PLANNING ASSESSMENT REPORT

DELEGATE REPORT

Application Details			
Application Number:	PA20240018	Planner:	Adam Moar
Application Description:	Construction of workers accommodation		
Application Received:	15 May 2024		
Land / Address:	21 Church Street Minyip 3392		
Zoning:	Public Use Zone Health and Community (PUZ3) Transport Zone (TRZ)		
Overlays:	Nil		
Under what clause(s) is a permit required?	<p>Clause 36.01-1: A permit is required for the use of the land as accommodation. (PUZ)</p> <p>Clause 36.01-2: A permit is required to construct and carry out works for an accommodation (Section 2 Use).</p> <p>Clause 52.29-2: A permit is required to create or alter access to a road in a Transport Zone 2.</p>		
Vicsmart	No		
Current Use & Development:	Vacant		
Land Use Terms:	Accommodation		
Cultural Heritage Management Plan details	Not applicable

Figure 4 Acoustic Screening Locations

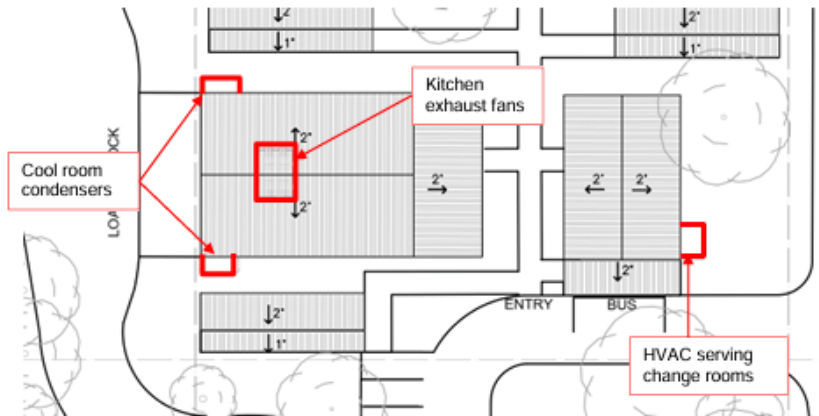
As discussed in Section 4.2, without noise mitigation the proposed operation complies only with the day and evening time criteria. To satisfy the requirements of the Noise Protocol, the following mitigation measures have been adopted by the client following AECOM's recommendation:

- Install an acoustic screen around the following;
 - HVAC serving the changing rooms,
 - Cool room condensers, and
 - Kitchen exhaust fans
- Screens to be constructed from a non-perforated material with a minimum 8kg/m² mass.
- Screens to be constructed a minimum 500mm higher than the top of HVAC serving the change rooms and cool room condensers. Minimum 800mm higher than the top of kitchen exhaust fans.
- Screens to be constructed in the locations shown below

Note, a combination of quieter equipment and acoustic screening may be used.
